DeKalb County Historic Preservation Commission

Staff Report

E. 1208 Oxford Road, Michael Nualla. Demolish a greenhouse and deck, construct a rear addition, construct a deck and stairs, install a side entry door, modify roofline, and install planting strips in the existing driveway. **1247408.**

AS NOTED SITE PLAN

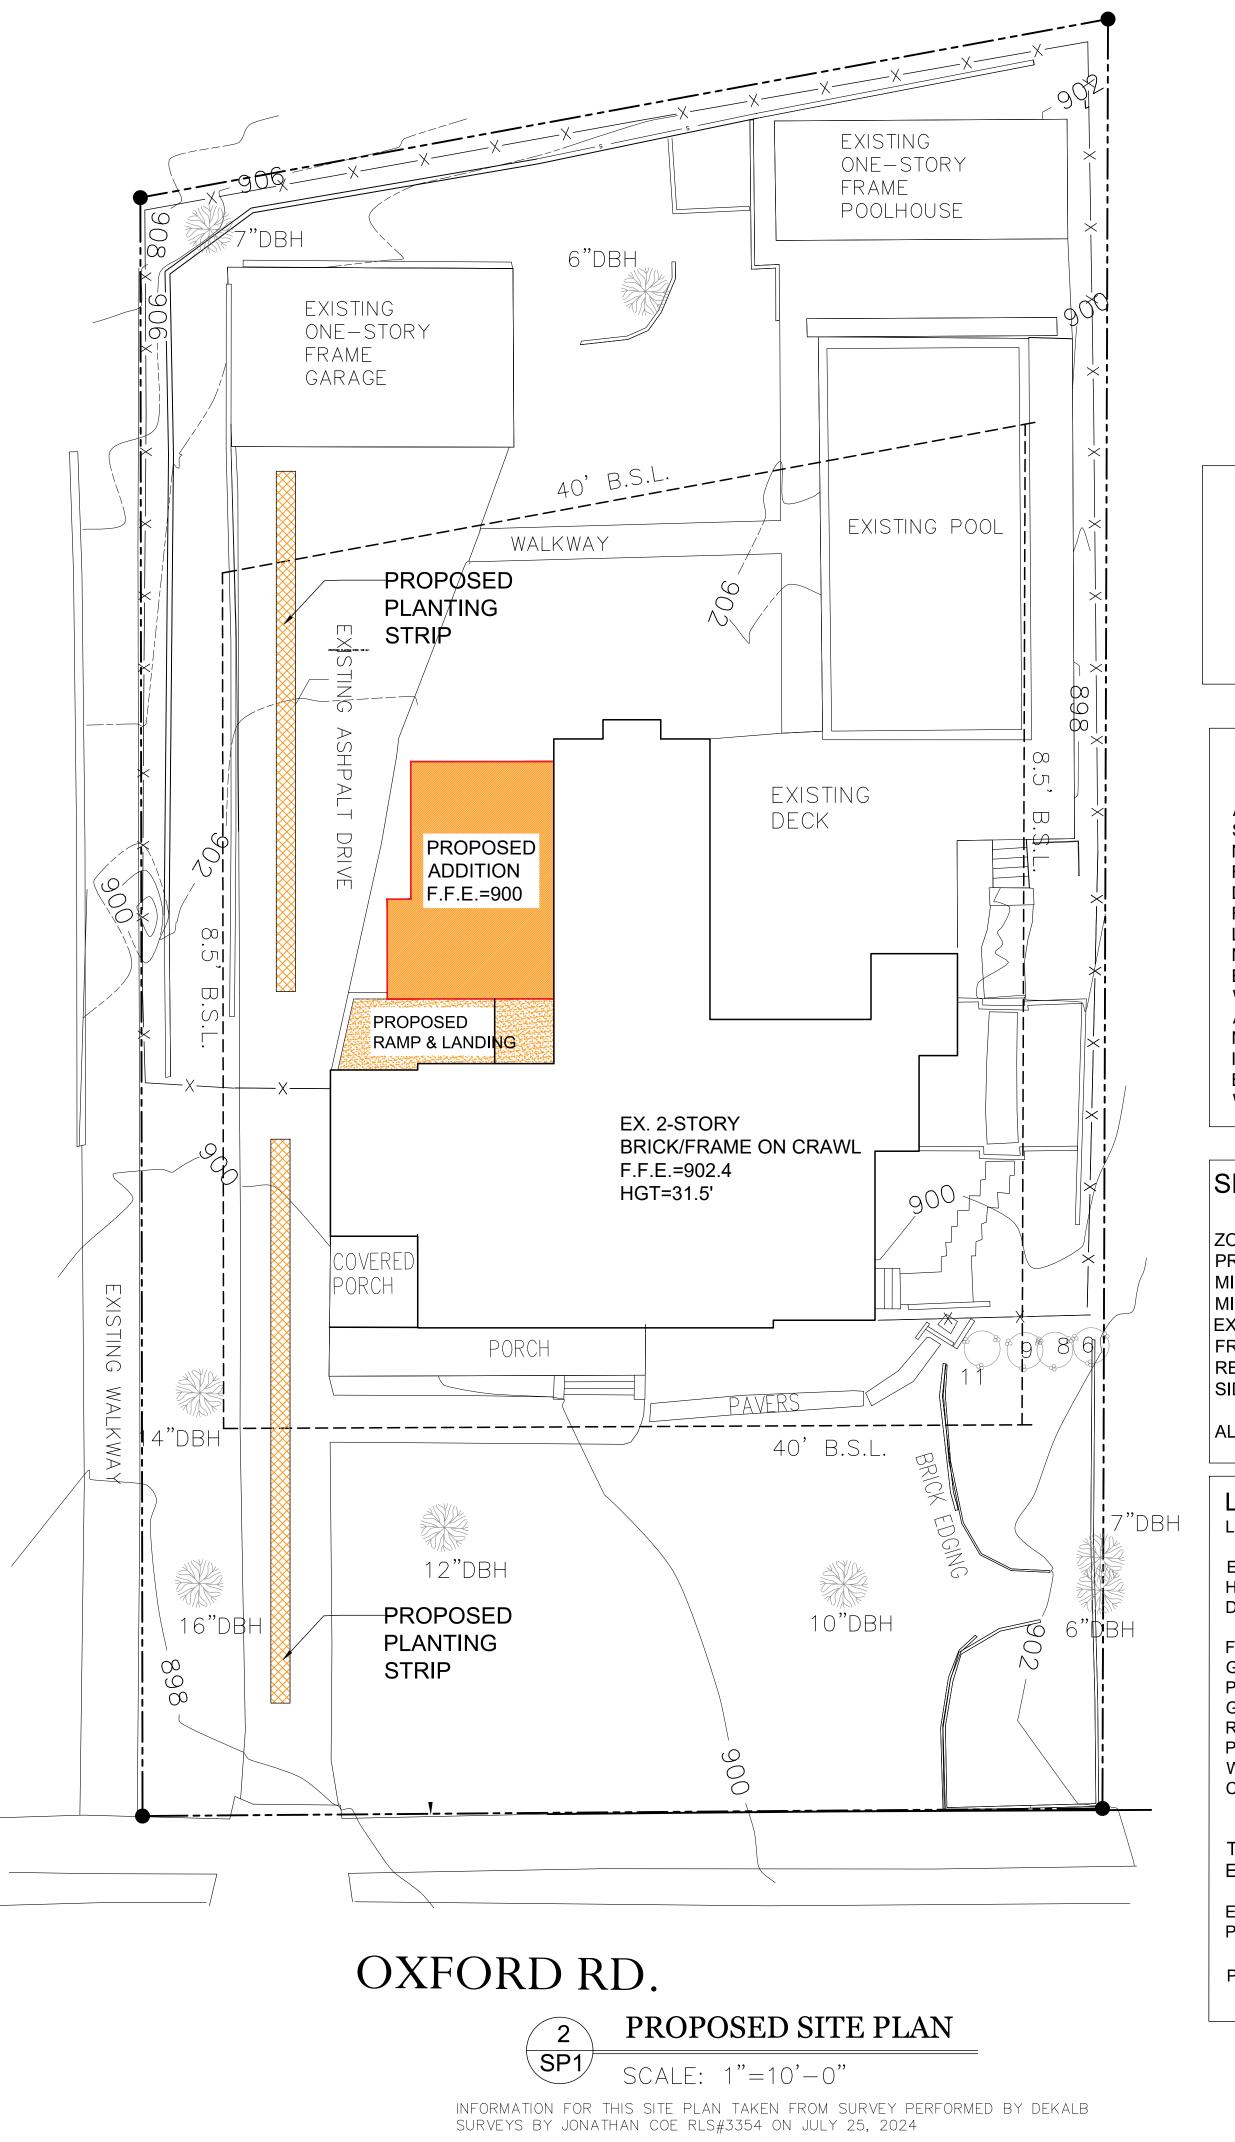
- 6. Install planting strips in existing driveway. Two planting strips will be installed in the center of the existing asphalt driveway. One planting strip will be installed near the front of the property, extending from the front yard to the rear corner of the main structure. The second of the planting strips will be installed on the rear of the driveway, extending from the front corner of the proposed rear addition to the front of the existing garage. Both planting strips will be filled with grass.

- 1. What will be planted in the proposed planting strips (grass, terf, flowers, etc.)?
- 2. Will the proposed addition extend beyond the rear corner of the main structure? Will the addition be visible in any way from the front of the property?
- 3. Can you provide a description of the proposed modification for the roofline? Will only the standing seam roofs be replaced and the slopes increased? Will there be any change to the historic clay-tile roofing?

1. Grass will be planted in the planting strips.

AS-BUILT ROOF PLAN SCALE= 1/4"=1'-0"

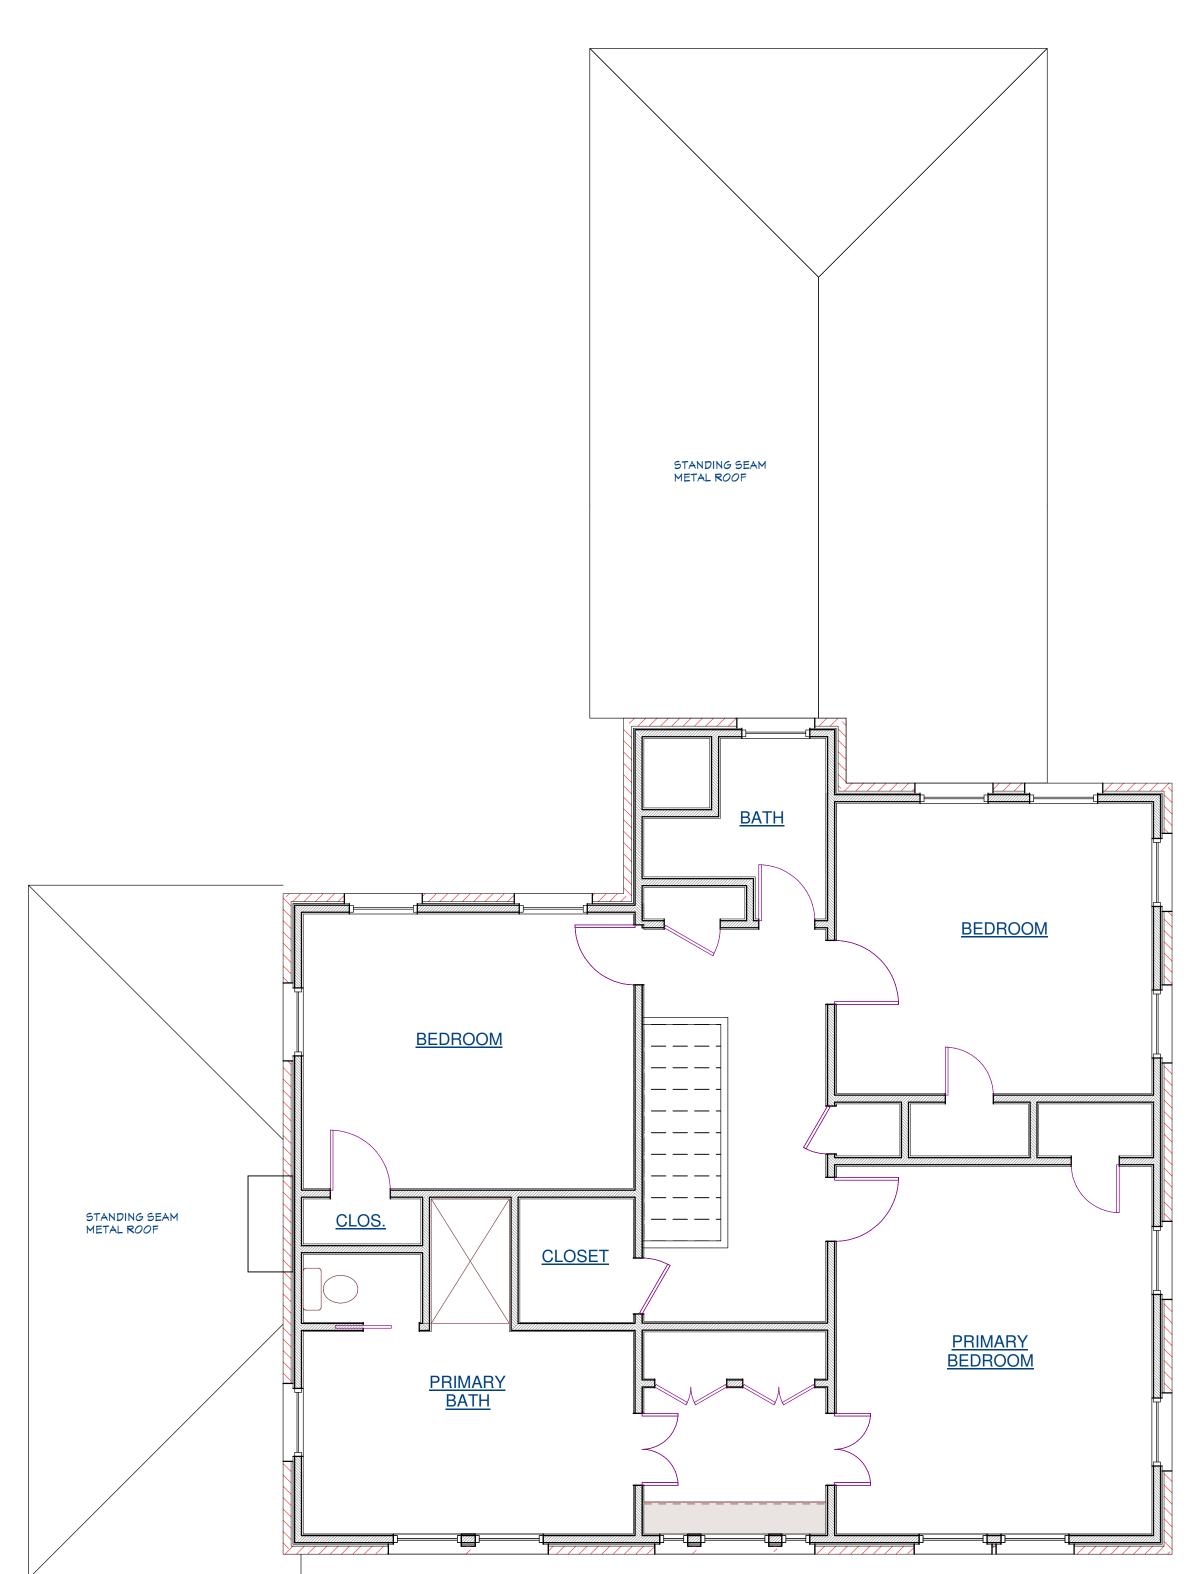
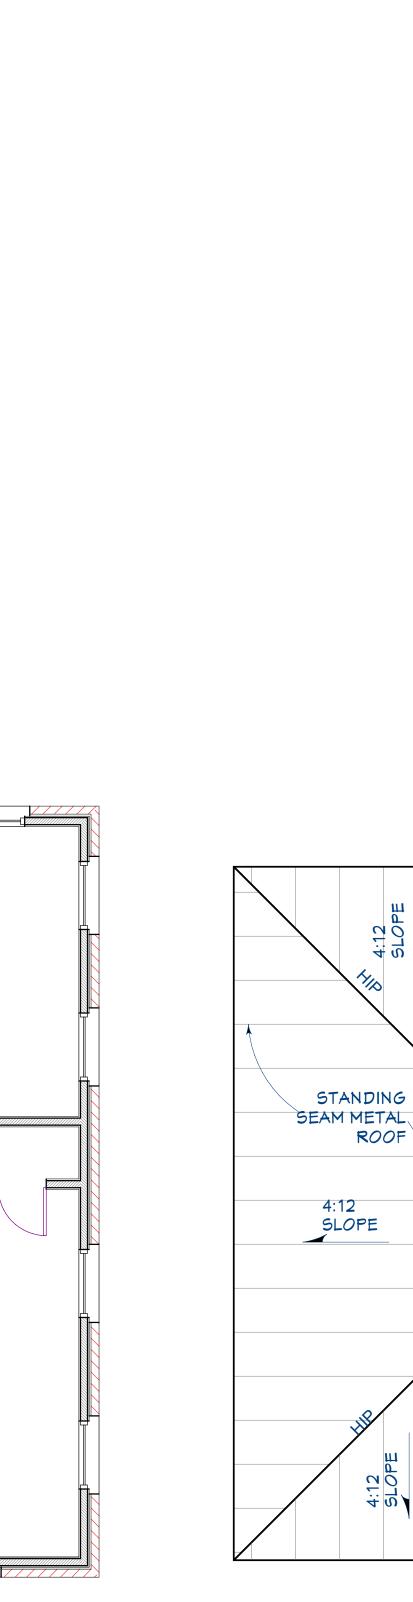
- 5. Modify roofline. The standing seam metal roof above the family room will be extended to create a hipped roof. This hipped roof section will create a higher ridge that will tie into the roofline of the new addition. The clay tile roofing on the main structure will remain unaffected.

- 2. The Addition **does not** extend beyond the rear corner of the main structure. The addition will **not** be visible from the front of the property. It is set back from the side elevation so that it will not impact the front elevation of the house. There also is a 6' fence/gate on the left side of the house that obscures any views of the back of the house.
- 3. Only the standing seam roof will be impacted. The existing ridge above the family room will be extended to create a hip roof. This new hip section will create a higher ridge that will tie in with the proposed roofline of the new addition. There will be **no** change to the clay-tile roofing that will remain as-is.
